# Access Compliance Report

## Public Rights-of-Way

Intersection ID: 29723	Main Street: LANNIER_FALLS_LN	Cross Street: MEDOC_MOUNTAIN_DR	Location: S
ADA ID: E7136CE72993	Ramp Type: Perp	Initial Pass/Fail: Fail	Overall Compliance: No
Severity Score: 8.75			
Codes/Mitigation Info/Possible Solution		Field Measurements/Component Compliance

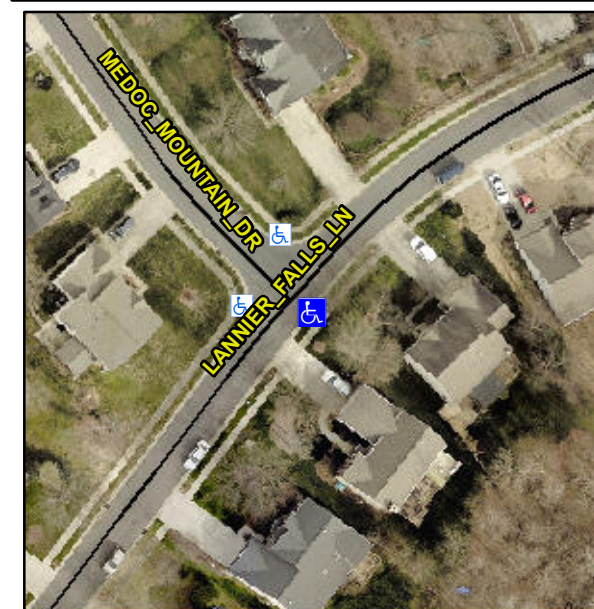
**Remove & Replace Entire Ramp.**

**R304.5.1**

Compliance	Description	Data	Compliance	Description	Data
N/A	Ramp Length (in)	48.5	Yes	Ramp Slope (%)	3.5
No	Ramp Width (in)	47.0	Yes	Ramp XSlope (%)	1.4
N/A	Flare Type LT	N/A	N/A	Flare Type RT	N/A
N/A	Flare Slope LT (%)	N/A	N/A	Flare Slope RT (%)	N/A
N/A	Flare Traversable LT?	N/A	N/A	Flare Traversable RT?	N/A
N/A	Landing Length (in)	N/A	N/A	DWS Provided?	N/A
N/A	Landing Width (in)	N/A	N/A	DWS Contrast?	N/A
N/A	Landing Slope (%)	N/A	N/A	DWS Length (in)	N/A
N/A	Landing X Slope (%)	N/A	N/A	DWS Full Width?	N/A
N/A	Landing Curb? (Y/N)	N/A	N/A	DWS Offset (in)	N/A
N/A	Shared Landing?	N/A			
N/A	Gutter Ponding?	N/A	N/A	Gutter Slope (%)	N/A
N/A	Gutter Lip Ht (in)	N/A	N/A	Gutter X Slope (%)	N/A
N/A	Painted X Walk1?	No	N/A	Painted X Walk2?	N/A
	X Walk 1 Direction	To N		X Walk 2 Direction	N/A
N/A	X Walk 1 Width (in)	N/A	N/A	X Walk 2 Width (in)	N/A
	X Walk 1 Slope (%)	0.9		X Walk 2 Slope (%)	N/A
	X Walk 1 X Slope (%)	3.1		X Walk 2 X Slope (%)	N/A
